Project Number: 2023-4439

**RE: FOOTE MINERAL SUPERFUND SITE GROUNDWATER & SURFACE WATER ANALYSIS REPORT
DATED JULY 13TH – RESPONSE TO EPA COMMENTS FROM SEPTEMBER 14TH 2023**

**Responses to EPA Comments
2023 Foote Mineral Superfund Site Monitoring Plan**

SHALLOW GROUNDWATER
ISOCONCENTRATION - LITHIUM

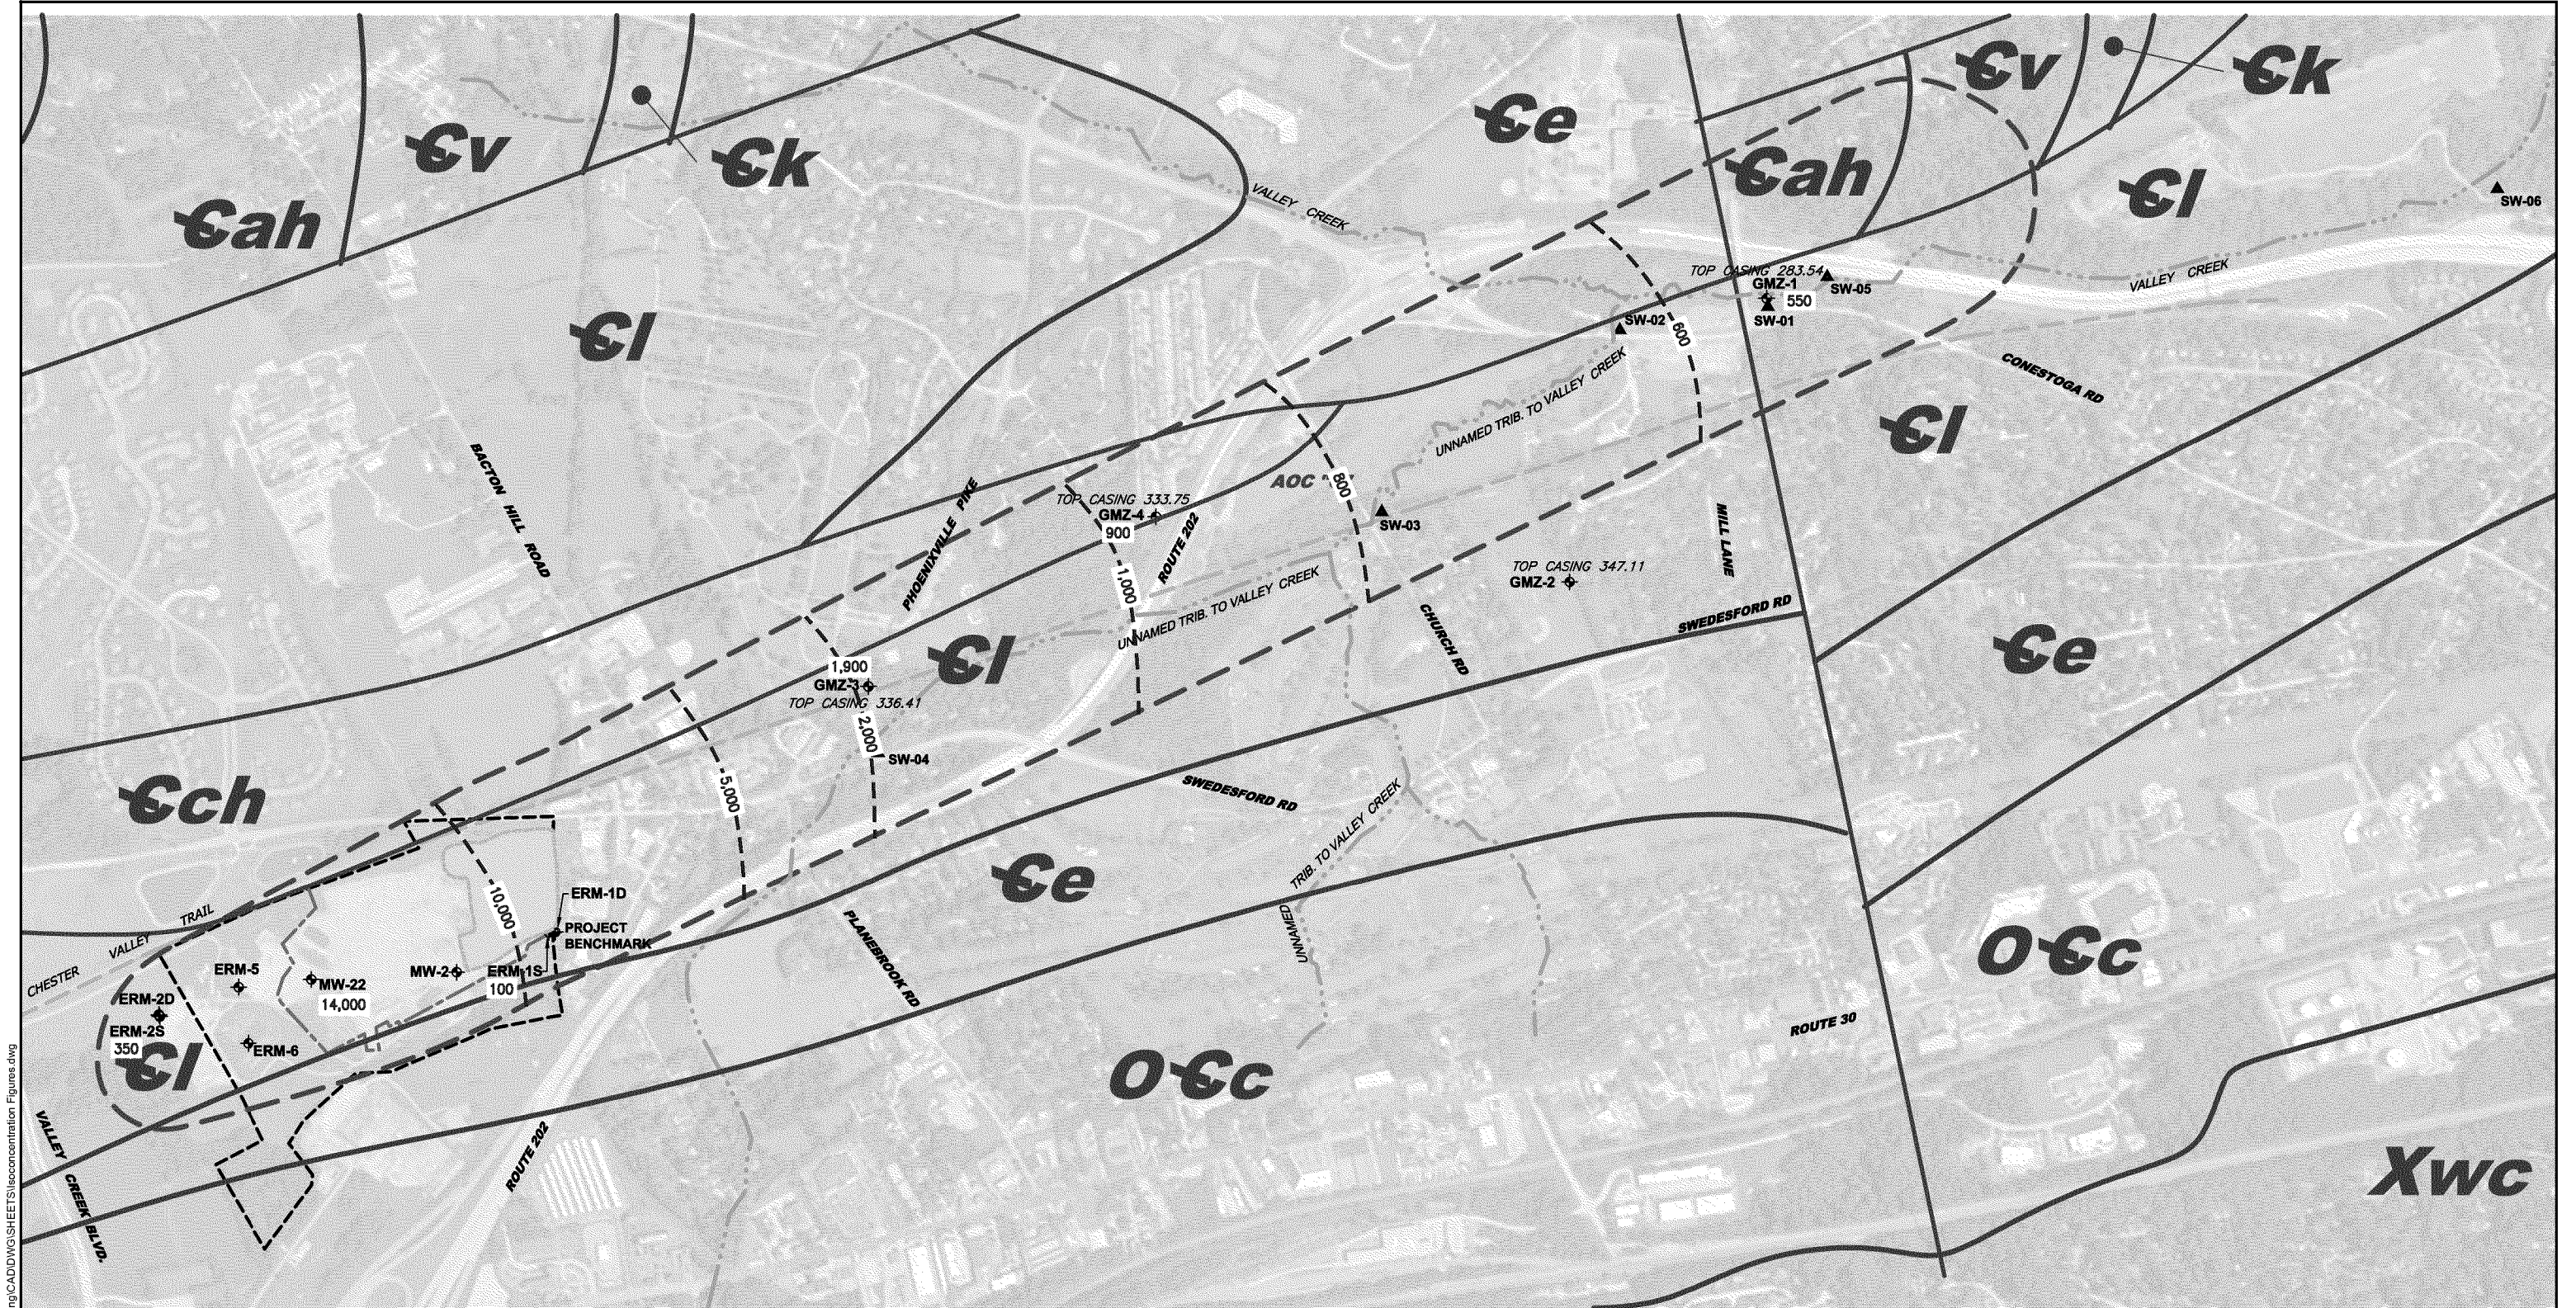
- 3. Can you please provide an updated figure overlaying the current groundwater lithium plume with contours displaying concentrations over a map of the Site, displaying the full extent of the plume for shallow, intermediate, and deep aquifer intervals.**

The information provided in the Monitoring Report was consistent with previous monitoring reports. At your request, this information is provided as Attachment B. Montrose notes the intermediate and deep plume concentrations shown on Figure A-2 and A-3 are nearly identical.
